Docket Item # 3
BAR CASE # 2009-0033

BAR Meeting
March 25, 2009

ISSUE: Alterations
APPLICANT: Michael Berry
LOCATION: 421 North Payne Street
ZONE: RB/residential

Figure 1. Existing conditions and proposed alterations on rear elevation: window to be bricked in and new opening to be created on one-story frame portion.

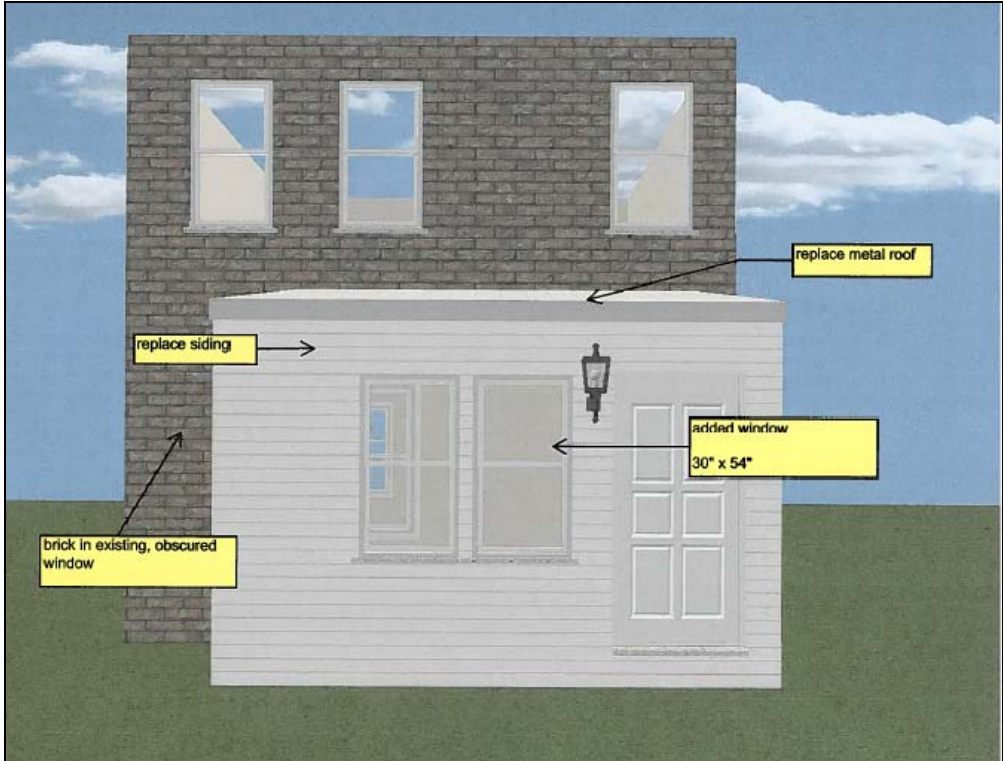
Staff has no objections to the proposed alterations. The proposed alterations are limited to the least visible elevation and are minimal. Filling in existing openings and creating new openings are common, and generally acceptable, alterations when reconfiguring interior space. In addition, the proposed materials, such as brick to match the existing, and a matching replacement wood window, are appropriate.

Figure 5. Location of proposed fence.

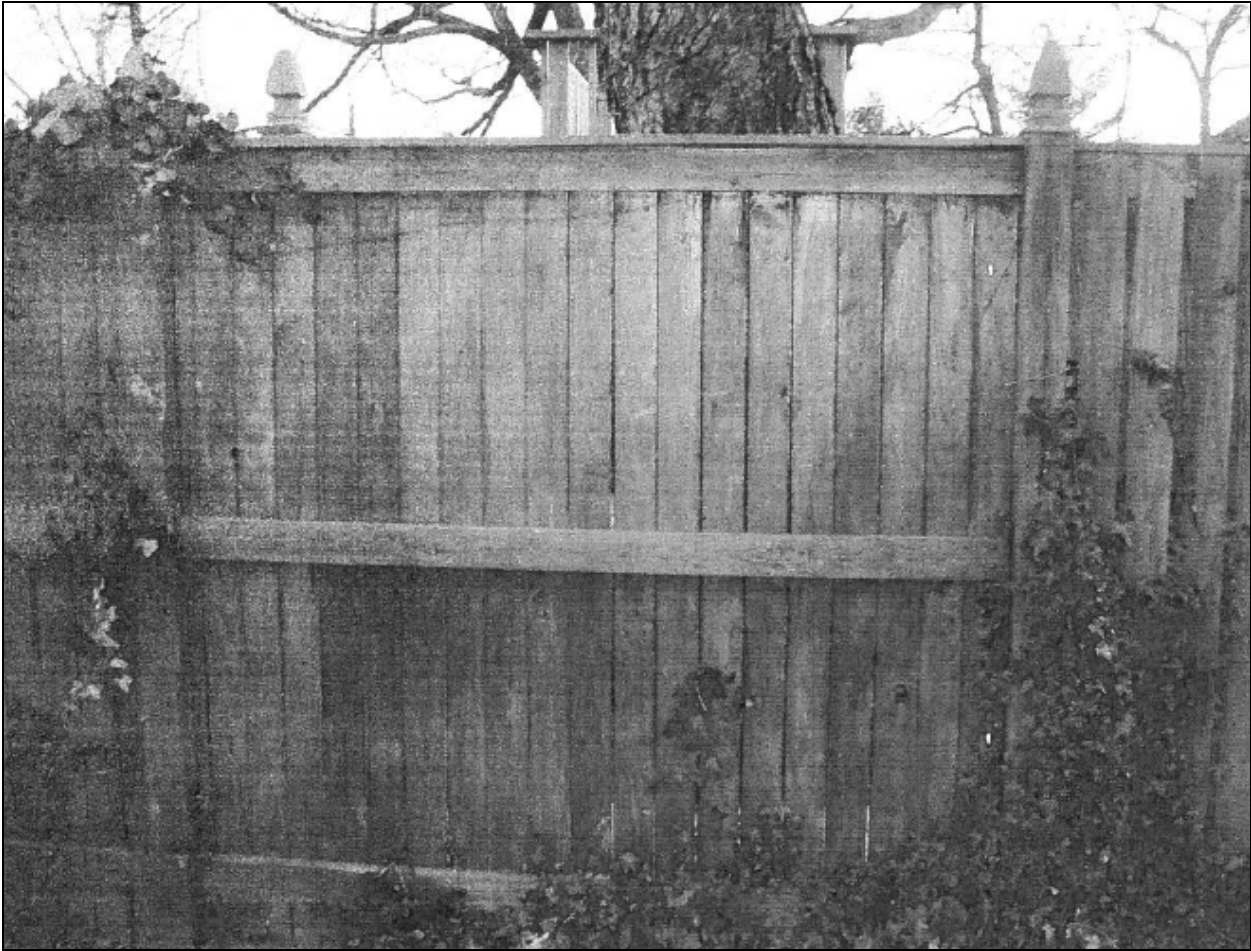
According to the *Design Guidelines*, "fences...should be appropriate in materials, design and scale to the period and character of the structure they surround" and "wood fences must be painted or stained." In Staff's opinion, both the design and materials of the proposed fence are compatible with the rowhouse and surrounding neighborhood.
